寄件者: pang hingyeun <[REDACTED]>
寄件日期: 2025年11月11日星期二 9:16
收件者: tpbpd/PLAND; Edwin Wai Shing YEUNG/PLAND
主旨: Planning Application No. A/YL-TYST/1327
附件: A_YL-TYST_1327.pdf; 流動環保廁所.pdf; Site Photo (1).pdf; Lot 1829 SA ss2 RP in DD121 Hung Shui Kiu_GPRR (1).pdf

Planning Application No. A/YL-TYST/1327

Geotechnical Planning Review Report
for the Proposed Ancestral Hall
at Lot No. 1829 SA ss.2 R.P.
in D.D. 121, Hung Shui Kiu,
Yuen Long,
New Territories

Plate 1

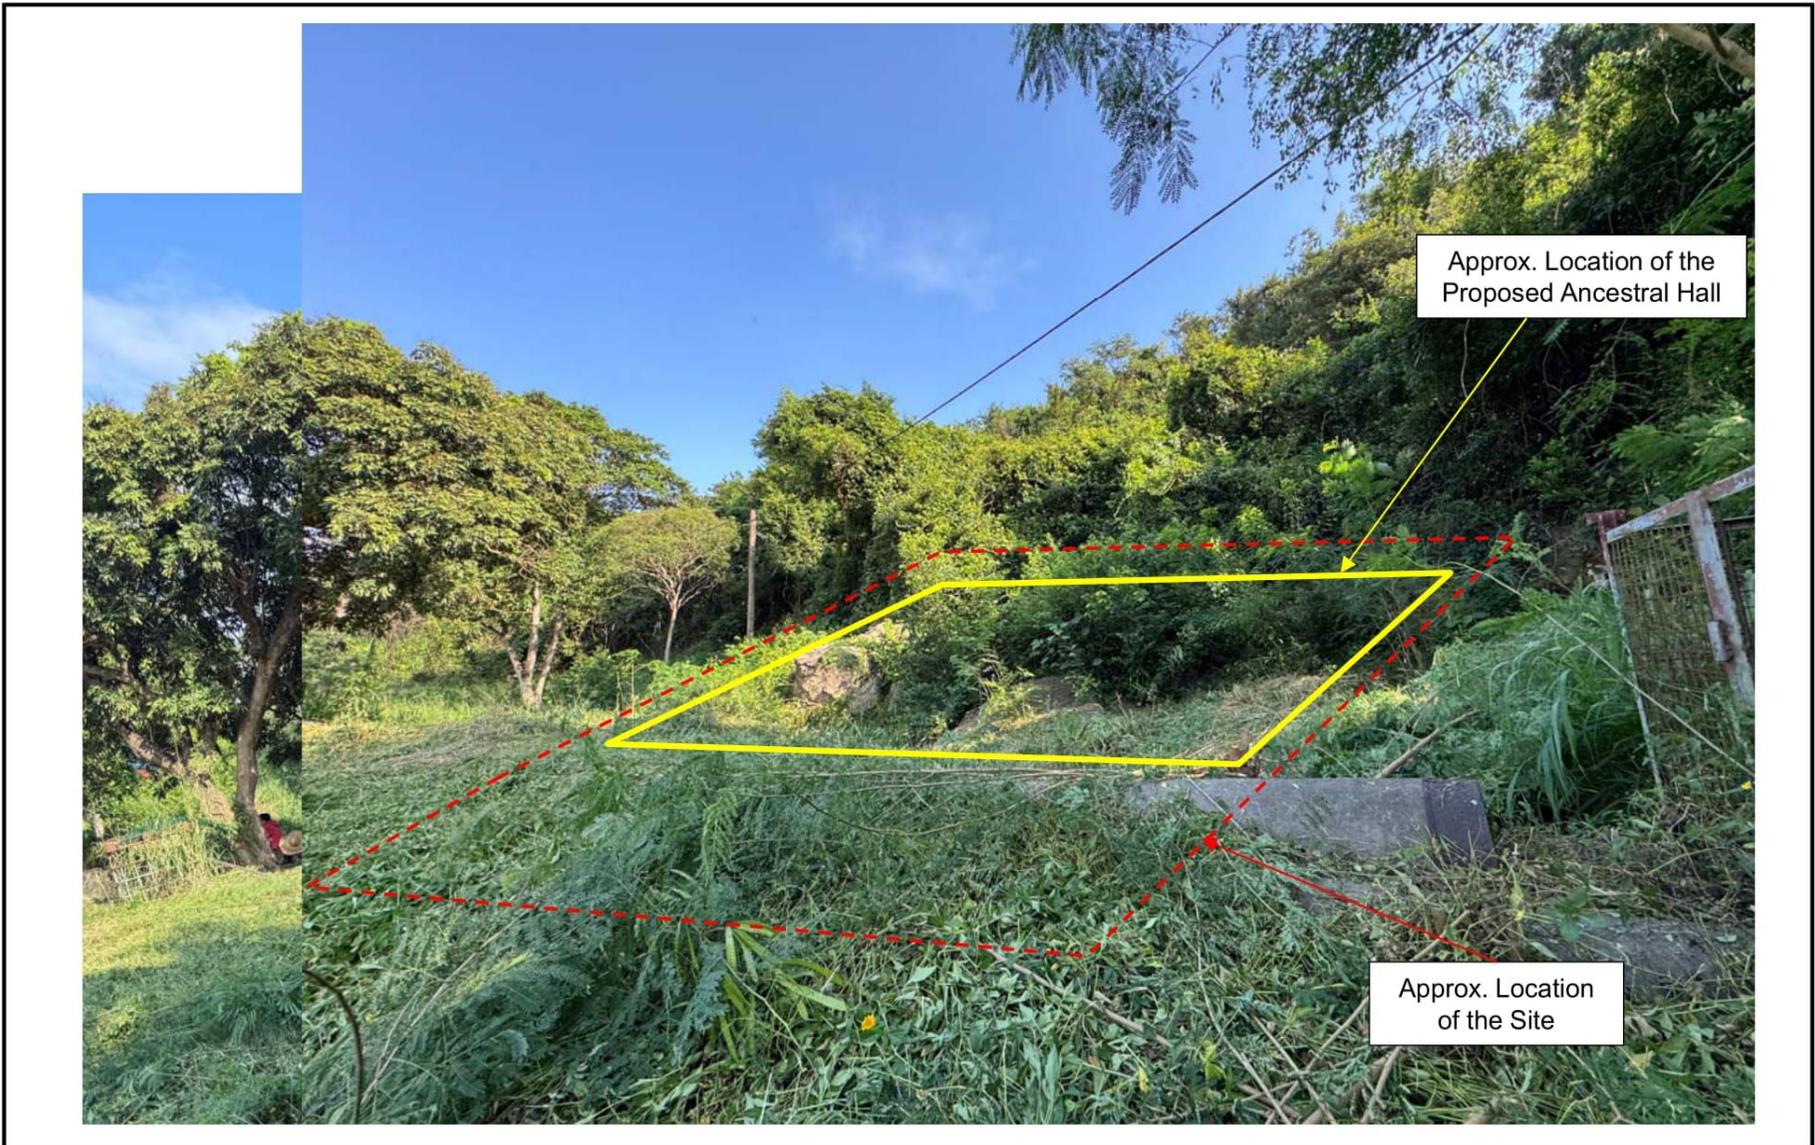
Urban Design and Landscape Section, Planning Department comments

The application site has not had any trees in the past. However, it is located within a private lot, where the owner purchased 3,000 trees years ago for planting on the lot and has assigned staff to care for them. If needed, we can add more trees around the application site. please refer to the site photo.

Environmental Protection Department comments

Since we only visit the site to pay respects to our ancestors during two festival each year, we find it more convenient to use portable eco-friendly toilets. After each ceremony, we arrange for an environmental cleaning company to come to the site to clean up the wastewater.

We will only burn incense indoors and will not engage in any activities involving the burning of joss paper.
